15 T dipole coil potting issues: status report

January 24, 2018

MDP High Field Dipole Demonstrator Design

Review questions and answers

Causes of impregnation shell buckling

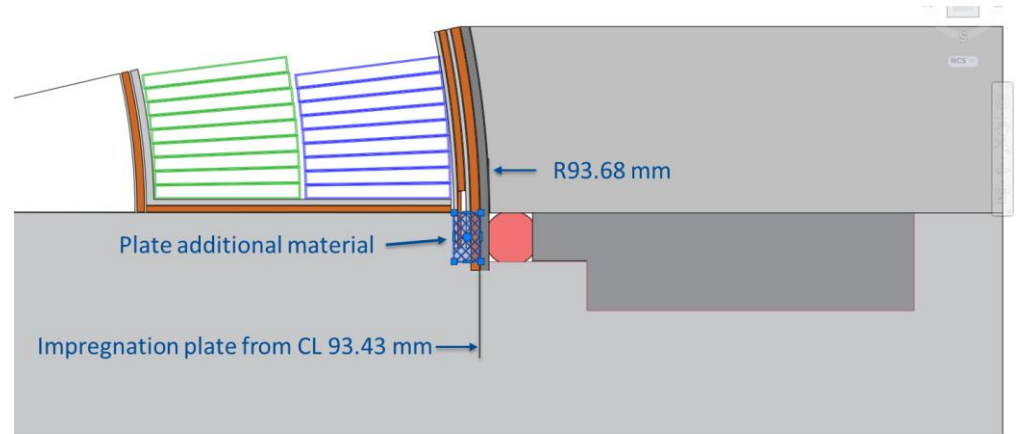
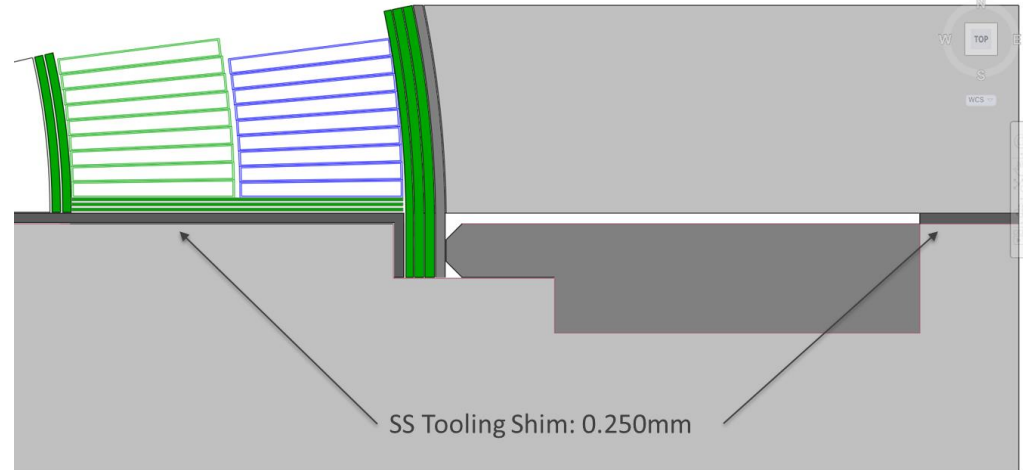
- Shell was initially rejected due to crease and it was slightly “short”
- Crease was rolled out by Igor and heavy duty rolling pin
- Undersize on arc length probably caused by crease

- **Outer surface dents**
 - Modify the impregnation base plate [186.3mm]
 - Trim the impregnation shell [2mm]
- **Inner surface pockets**
 - Increase mandrel OR by 0.127mm [sticky Kapton or Teflon tape]
 - Fill pockets with Stycast and re-cure

Repair coil HFD-CL2-003

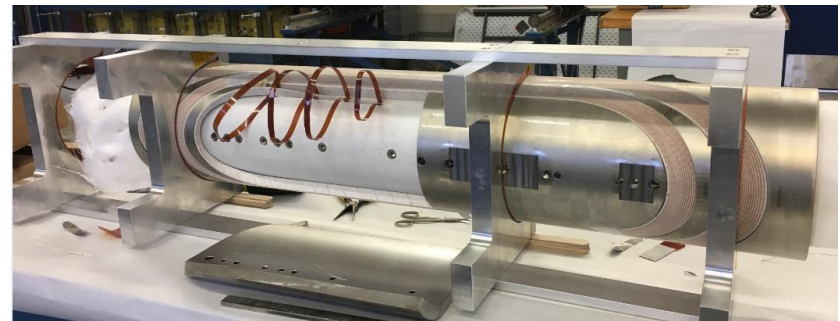
1. Remove OL pole blocks (done before)
2. Cut and open interlayer insulation
3. Remove IL-LE pole block (? Decision point #1)
4. Modify transition area
5. Put back the IL-LE pole block (? Decision point #2)
6. Fix interlayer insulation
7. Install OL pole blocks

The proposed plan of repairing coil HFD-CL2-003 appears viable, and would be the most efficient course. The back-up plan of winding a new coil using cable recovered from HFD-CL-001 also appears viable, but would be slower and use more resources.

1. After internal review, modify the parts and tooling as proposed.
 - a. Shell
 - b. Impregnation base plate
 - c. Mandrel
2. Adopt Recovery Option #1 to repair coil HFD-CL2-003. Develop a detailed plan through internal discussions, including consideration of the committee's comments. Conduct another readiness review before removing any more pole pieces and also before reinstalling the pole pieces.
